Site Instruction

SI 20

PROJECT : **Hampton Manor**
PROJECT No : 1136.13
DATE : June 14, 2018

Title: Mechanical Floor Precast Update

1:50 A701

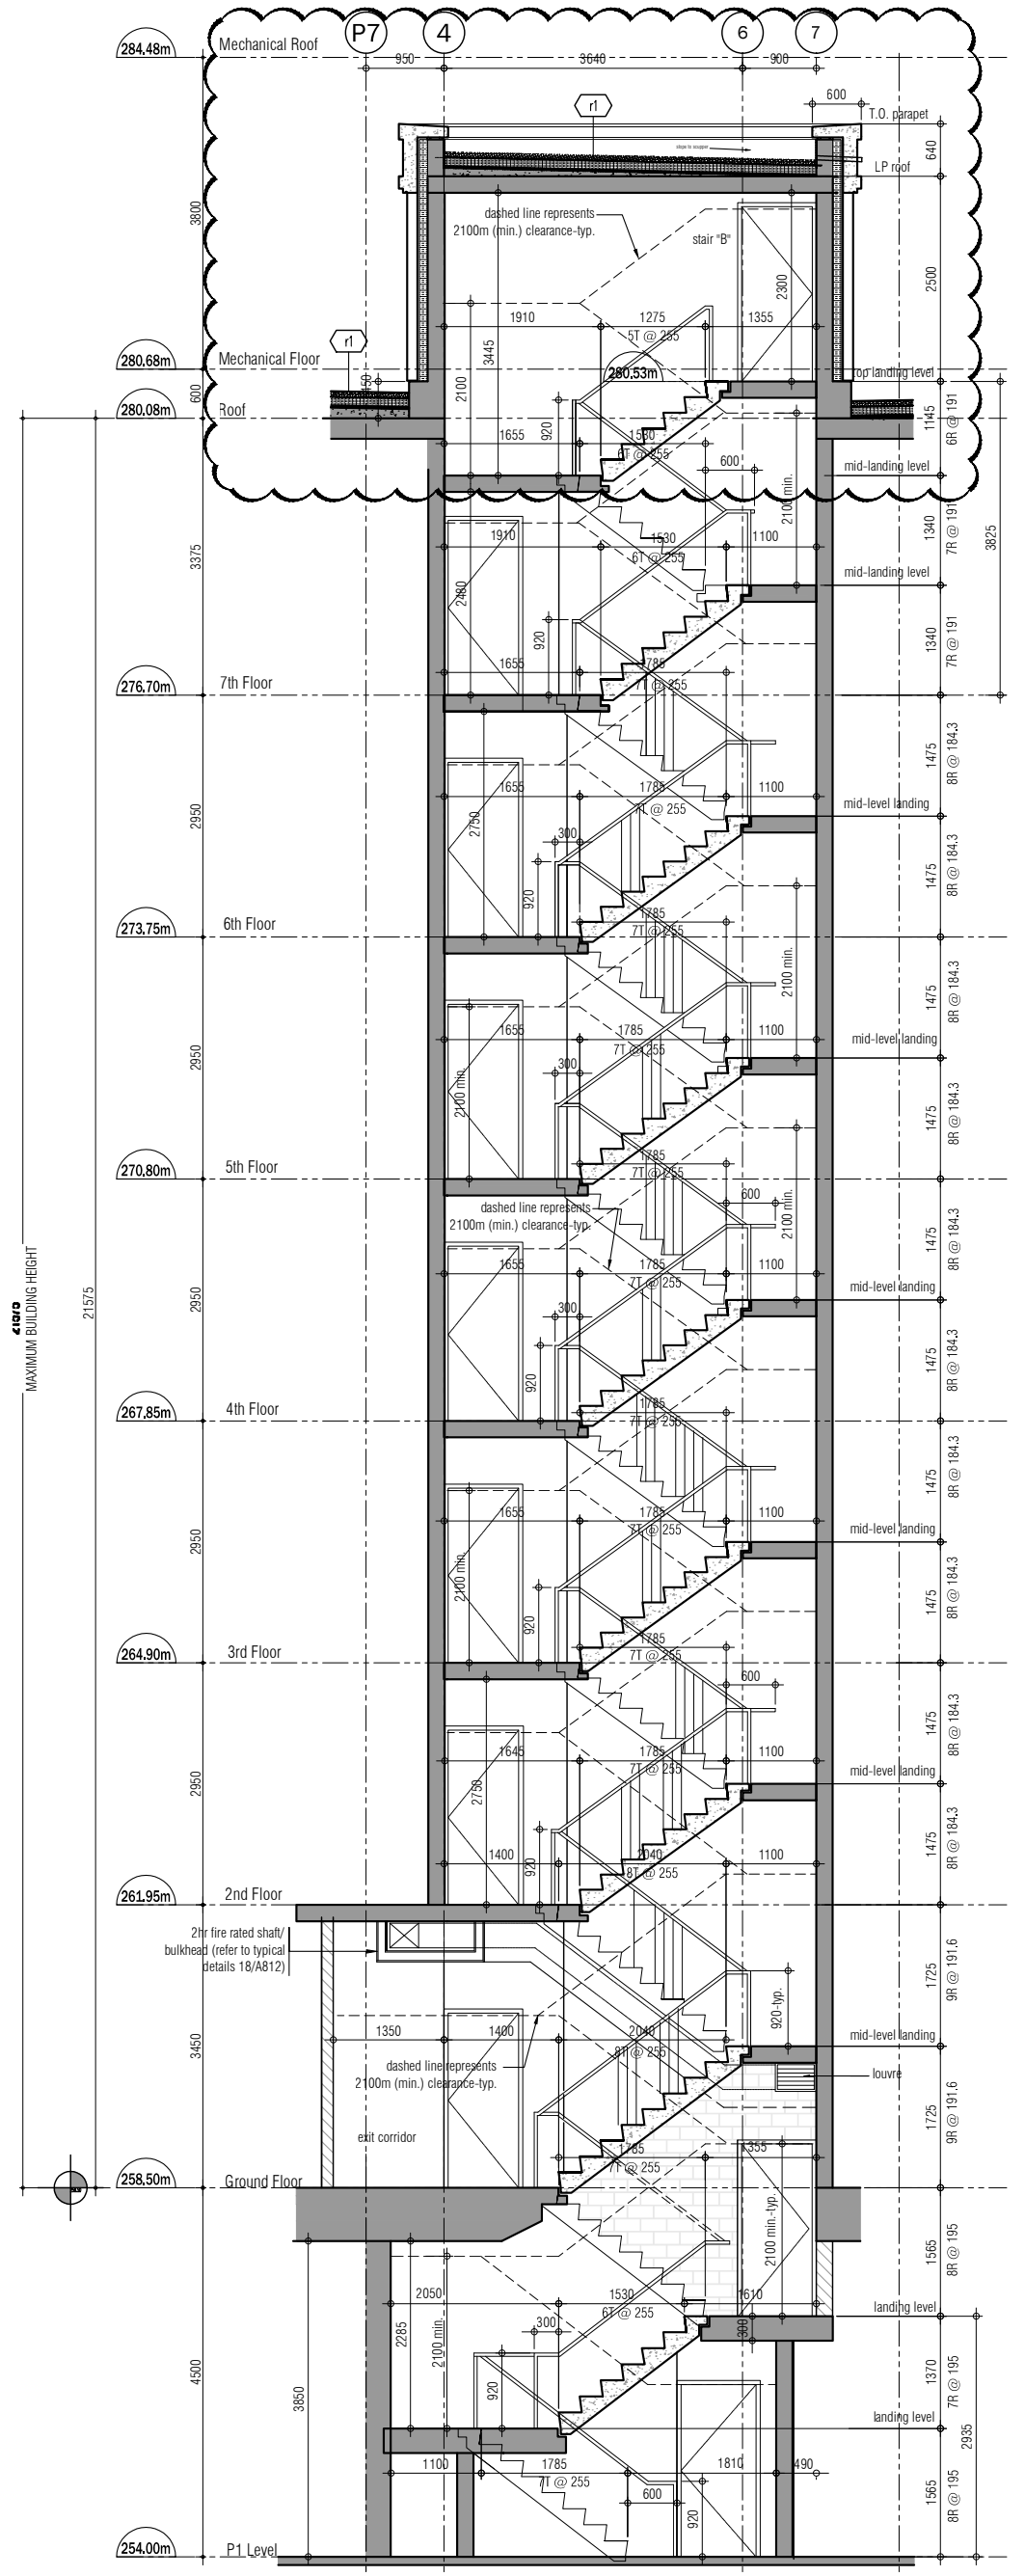
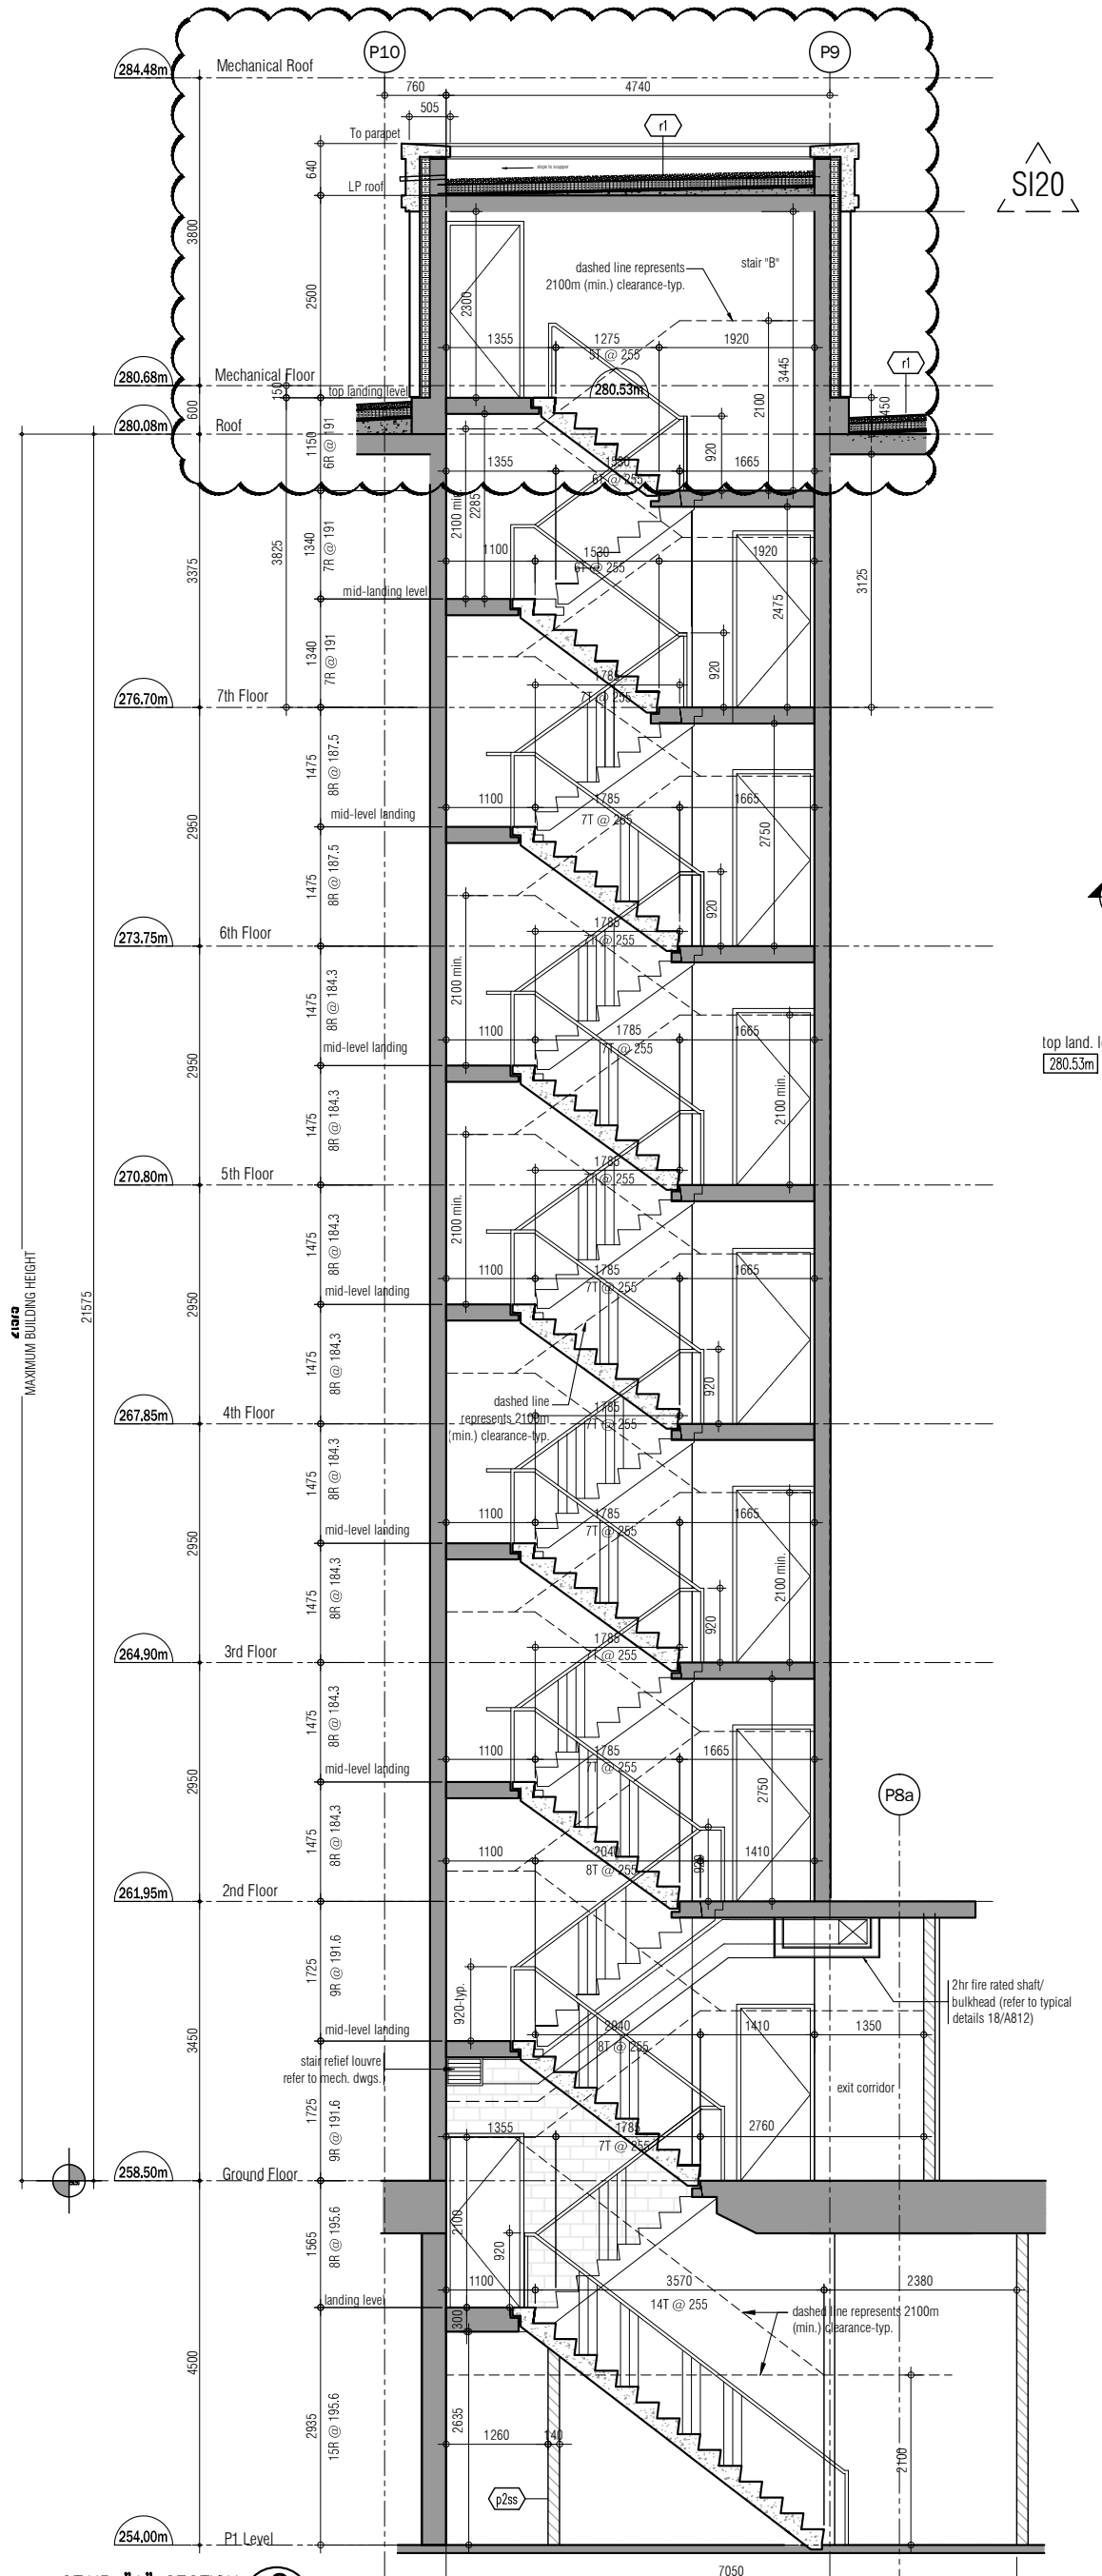
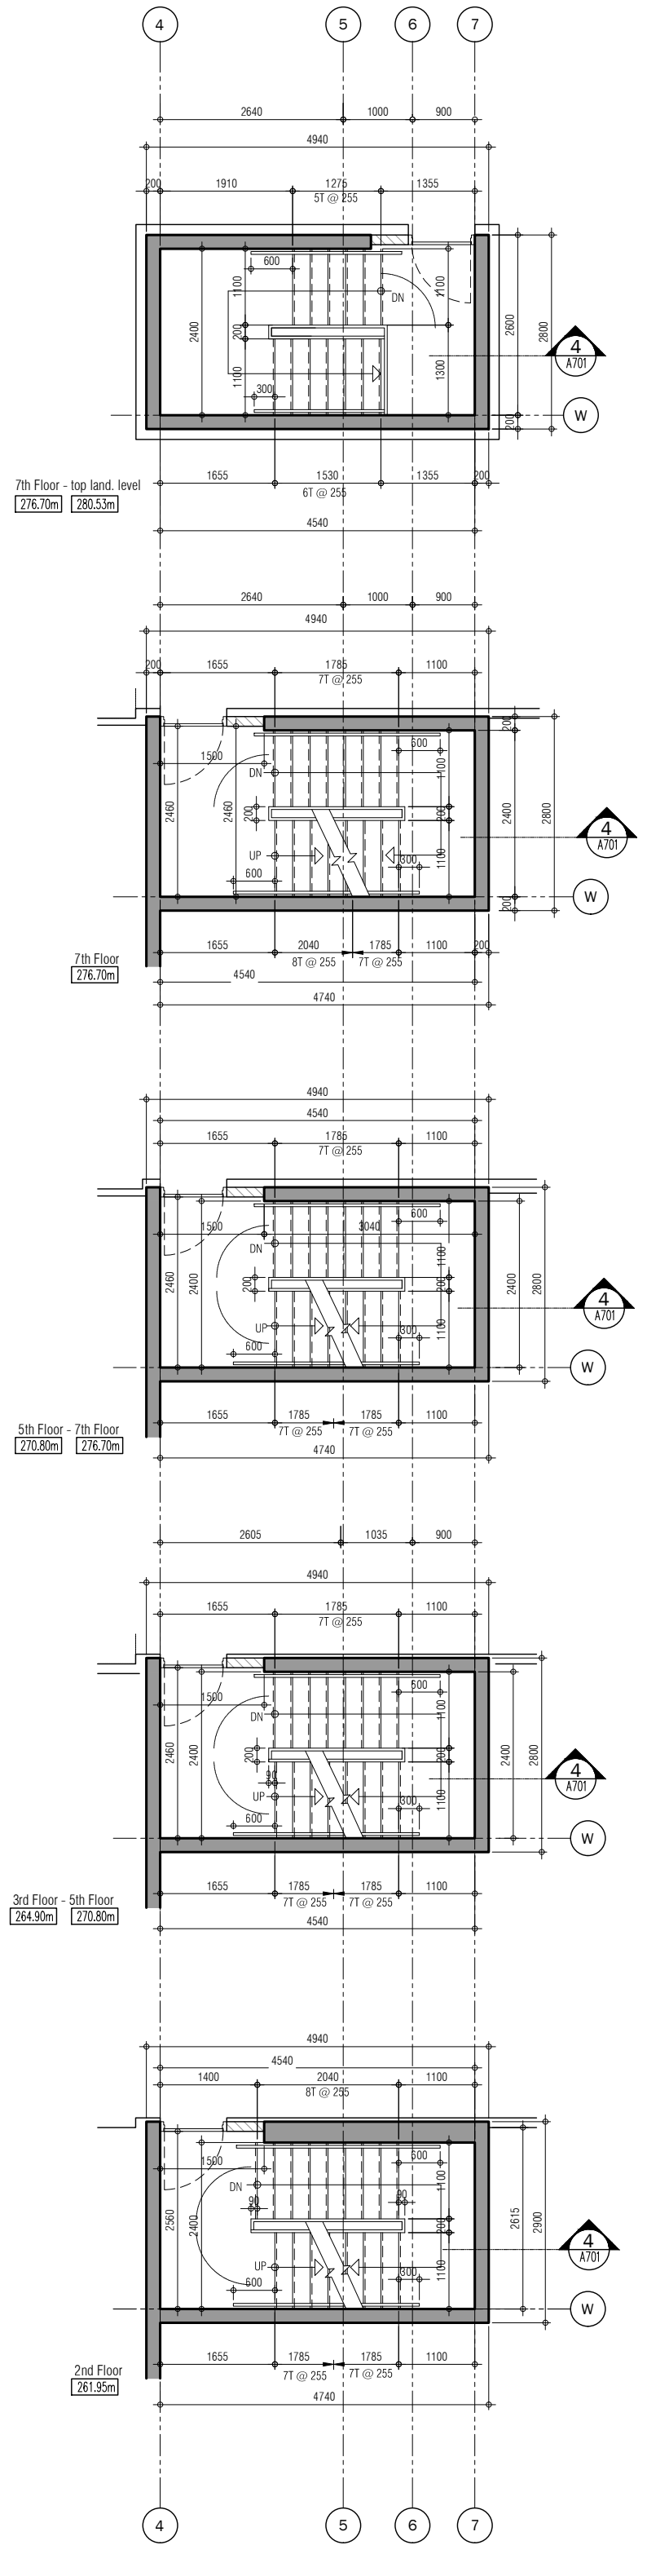
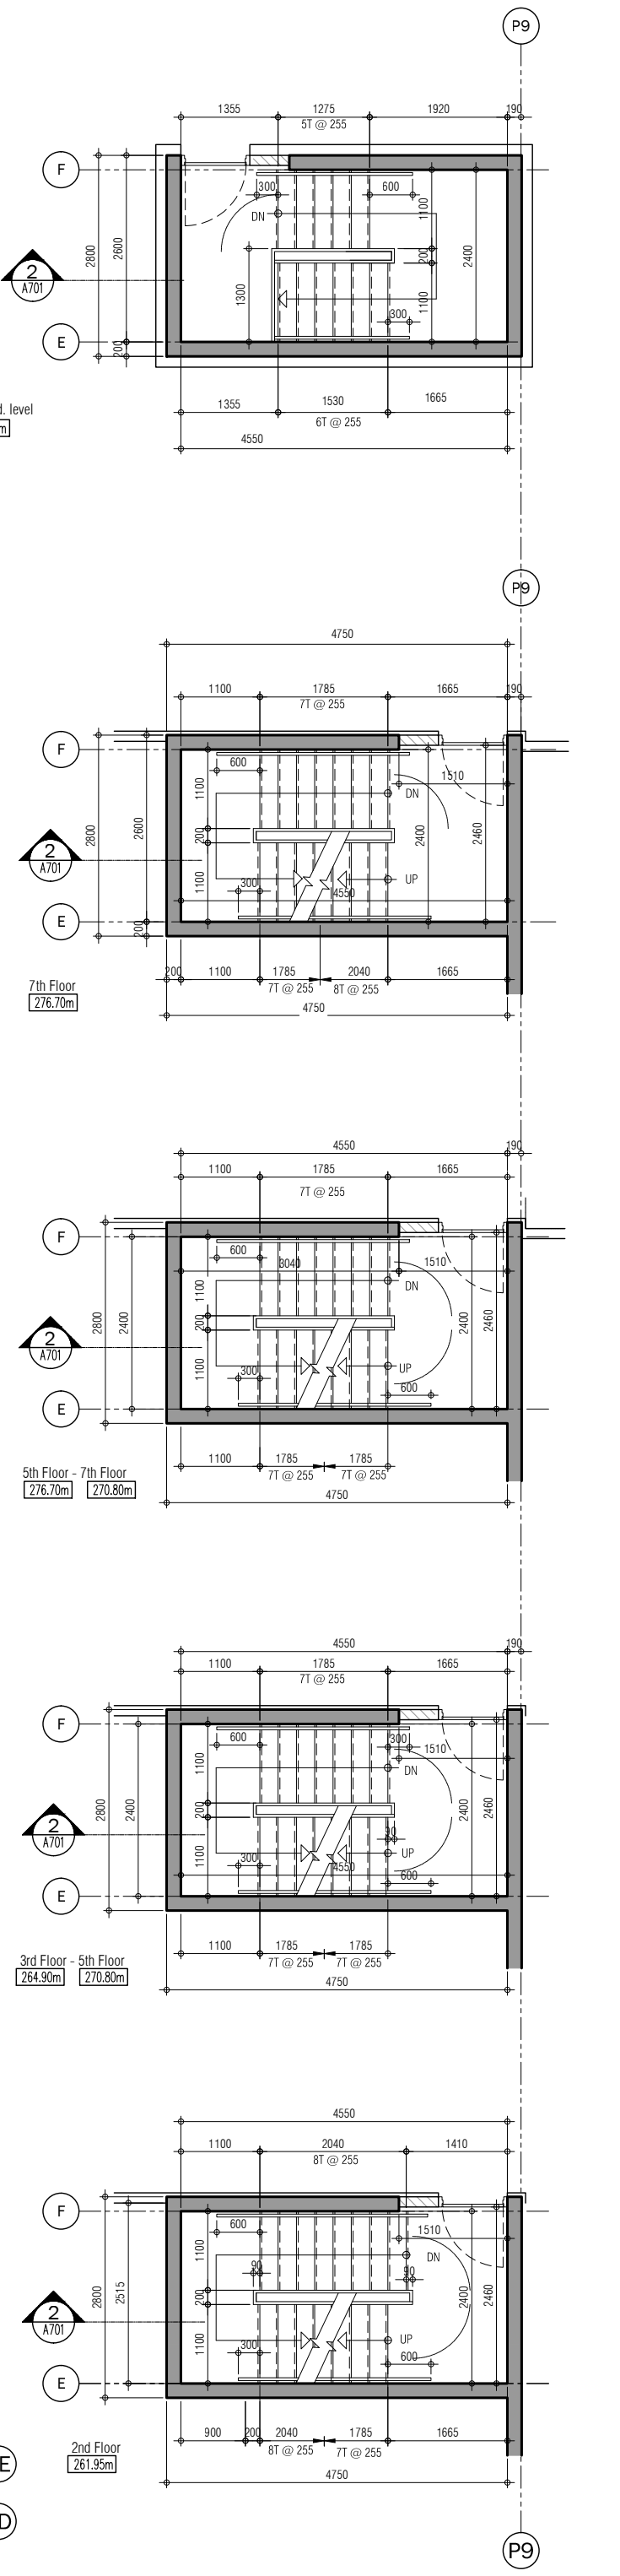
A701 – Stair Drawings
- Revising spandrel cladding to precast at stair A & B.
